# CITY OF ALBUQUERQUE

RE: **Swim Labs**  
**8110 Holly Ave NE**  
**Grading Plan Stamp Date: 6/24/19**  
**Hydrology File: C20D082**

Based on the submittal received on 6/25/19, the grading and drainage plan cannot be approved until the following are corrected:

## GRADING & DRAINAGE PLAN

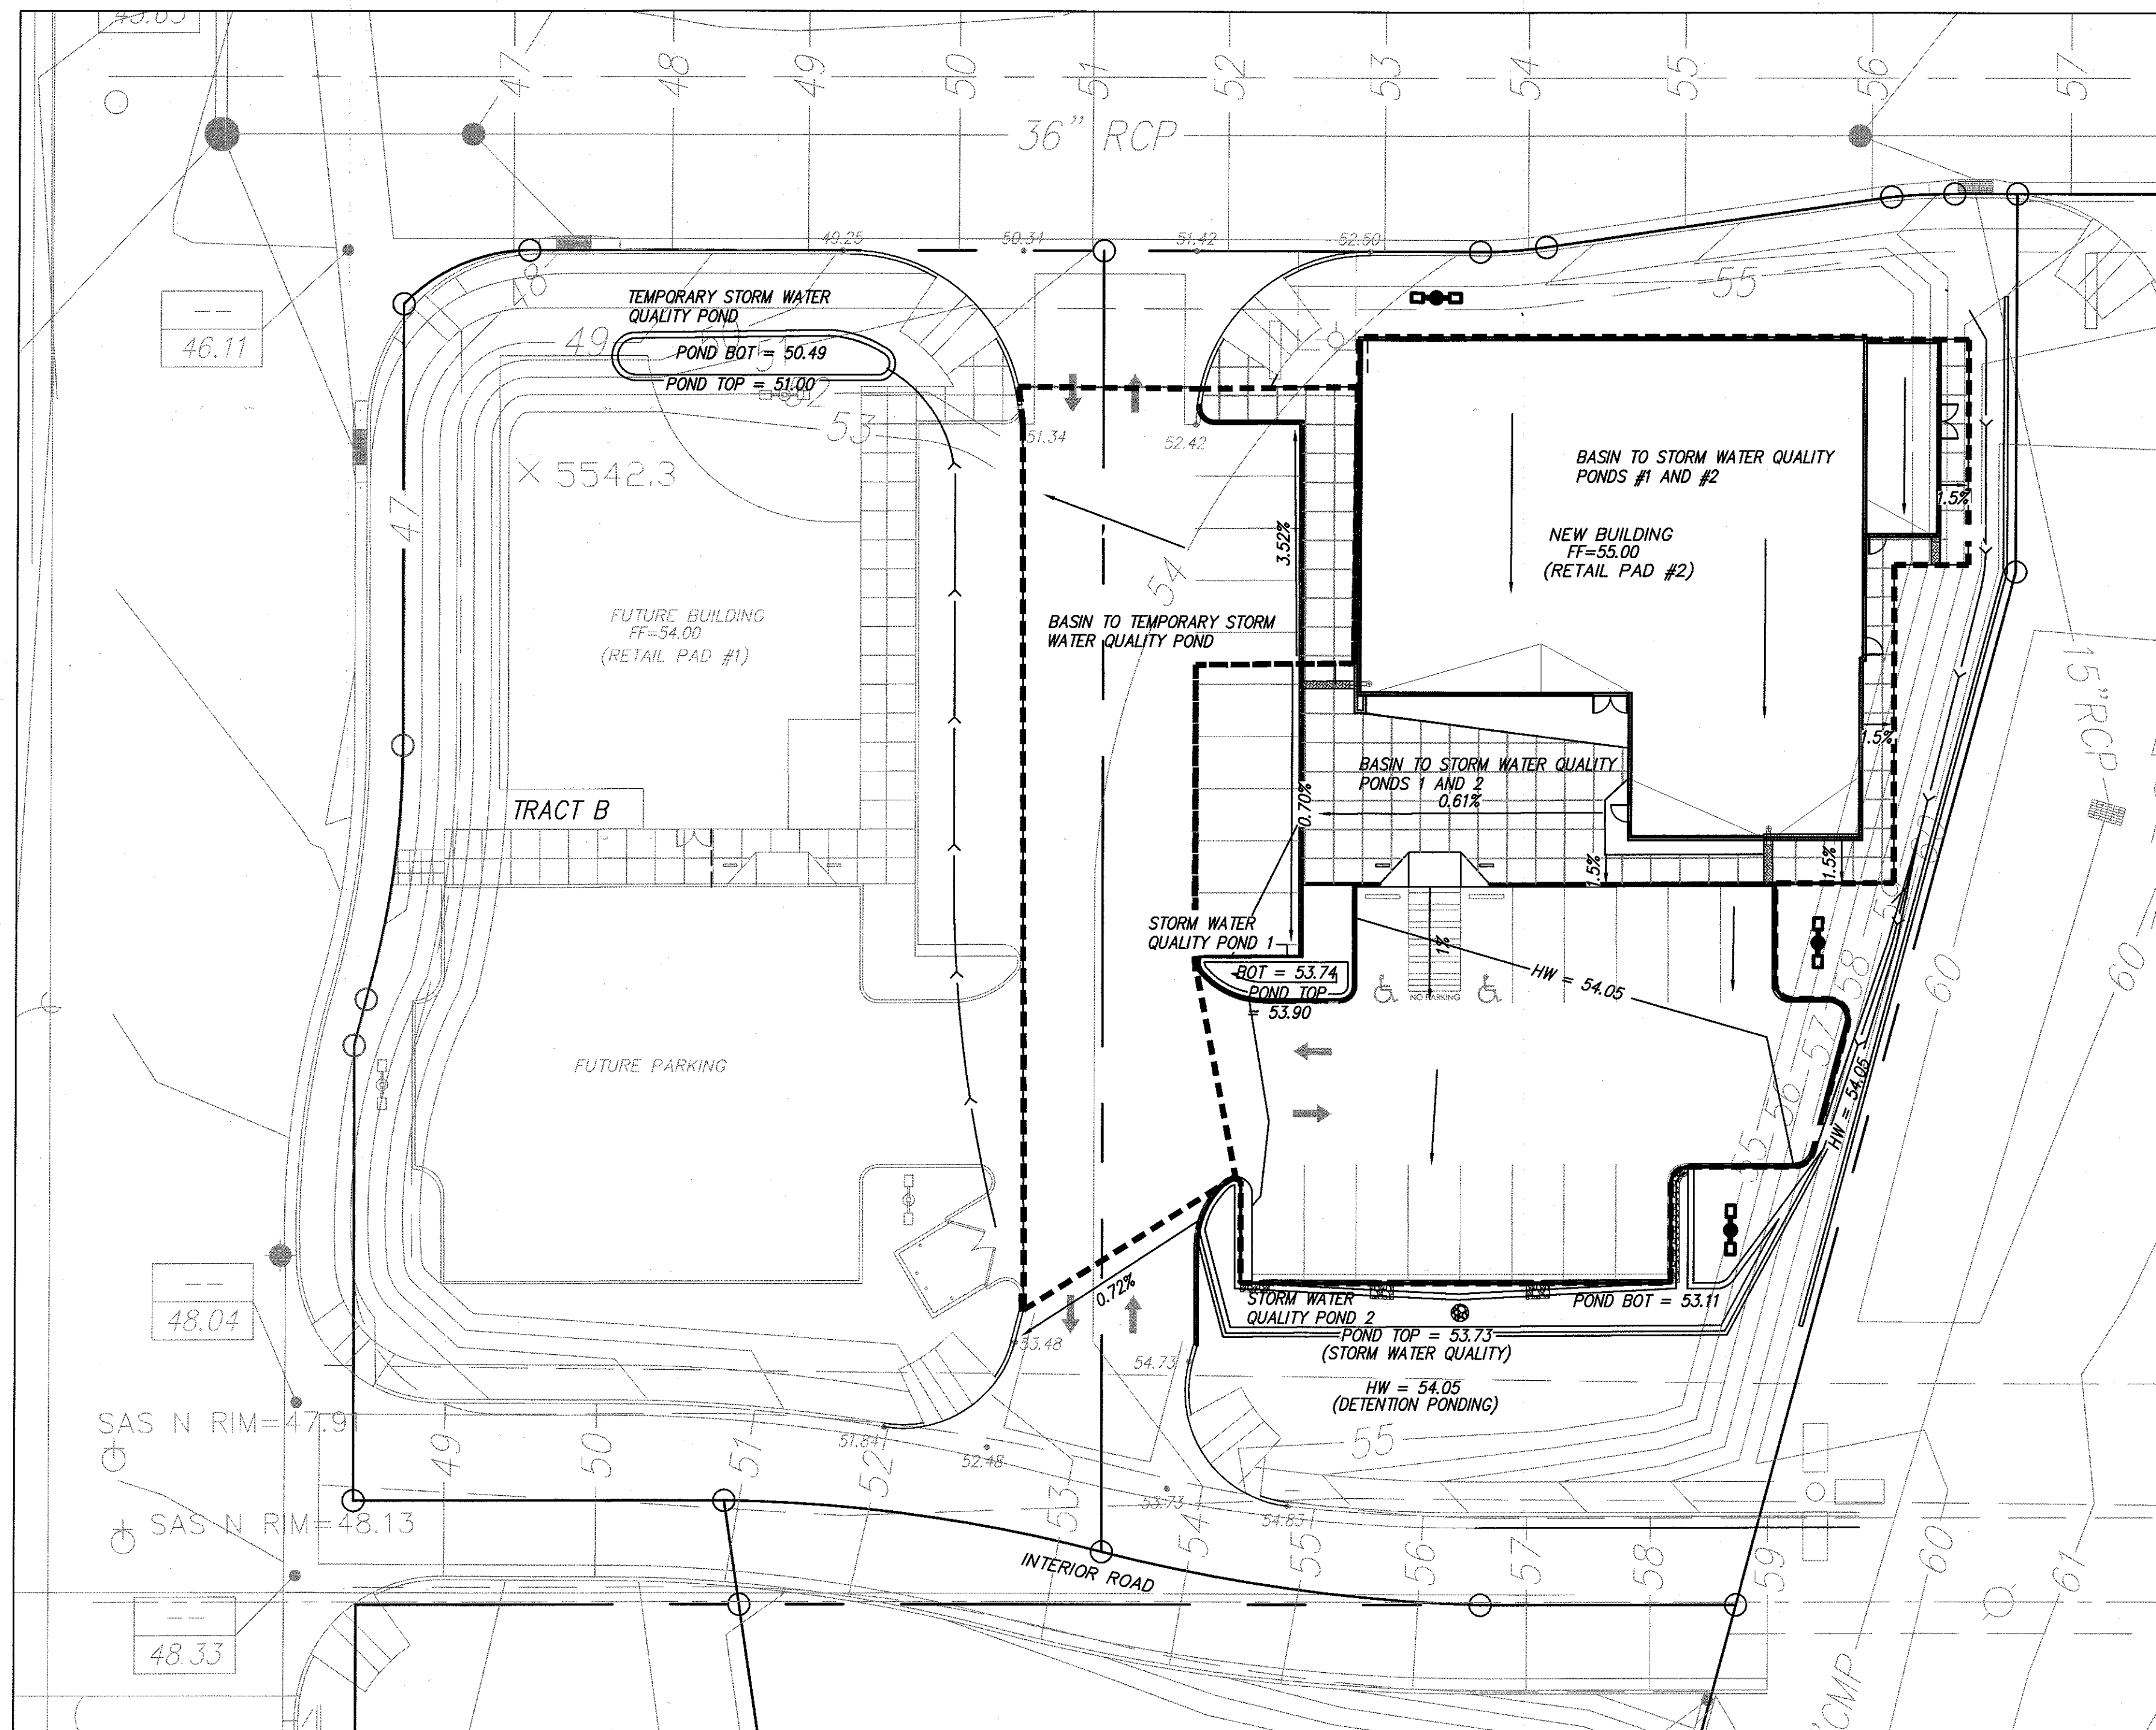
1. Provide proposed contours and proposed spot elevation in sufficient density to ascertain the proposed drainage pattern of the site.
2. A waterblock is likely required near the north driveway to ensure flows are routed to the tract B pond.

3. Subbasins need to be delineated and modeled in AHYMO or with the 40-acres-or-less method and must include all onsite drainage and upstream offsite flows.

4. The drainage plan must address all onsite drainage and upstream offsite drainage, not just the parking lot and building.
5. Remove the temporary markings from the tract B stormwater quality pond; these features are permanent and will need to be protected with a drainage covenant, signed by the underlying property owner.

6. Provide written and signed permission from the owner of Tract B for the grading, paving and pond construction on their property.
7. Provide project datum.

8. The complete AHYMO input and output files need to be provided, not just the summary. If you provide these separately, they must be bound and stamped by the engineer.

9. With AHYMO S4, be sure to use NOAA Atlas 14 precipitation depths in conjunction with the NOAA Atlas 14 distribution. Include the location map and tables obtained from the NOAA website. Using the NOAA Atlas 2 Precipitation depths (Found in the DPM), with the NOAA Atlas 14 Distributions results in an over-prediction of peak runoff ( $Q_{100}$ ). See [AHYMO AppNote-01](#), and the Hydrology website for more information regarding this.

10. The outfall for pond B is unclear. The AHYMO run seems to indicate a continuous outflow, but the obvious outfall is the drive entrance that has a crest elevation at 54.12'. The City does not accept infiltration as an outfall or credit it in pond sizing as pond bottoms generally silt-in and reduce the infiltration rate to nearly nothing.

11. The site must demonstrate adequate downstream capacity per § 14-5-2-12(G) of the Albuquerque Code of Ordinances.
12. Provide the Furr's Paseo del Norte drainage report and Hydrology approval letter. This report is missing in our database and needs to be recovered if it is to be used as the basis for this development.

13. Provide a cross lot drainage easement (paper or Plat) between the two tracts.
14. As a reminder, if the project total area of disturbance (including the staging area and any work within the adjacent Right-of-Way) is 1 acre or more, then an Erosion and Sediment Control (ESC) Plan and Owner's certified Notice of Intent (NOI) is required to be submitted to the Stormwater Quality Engineer (Curtis Cherne, PE, [ccherne@cabq.gov](mailto:ccherne@cabq.gov), 924-3420) 14 days prior to any earth disturbance.
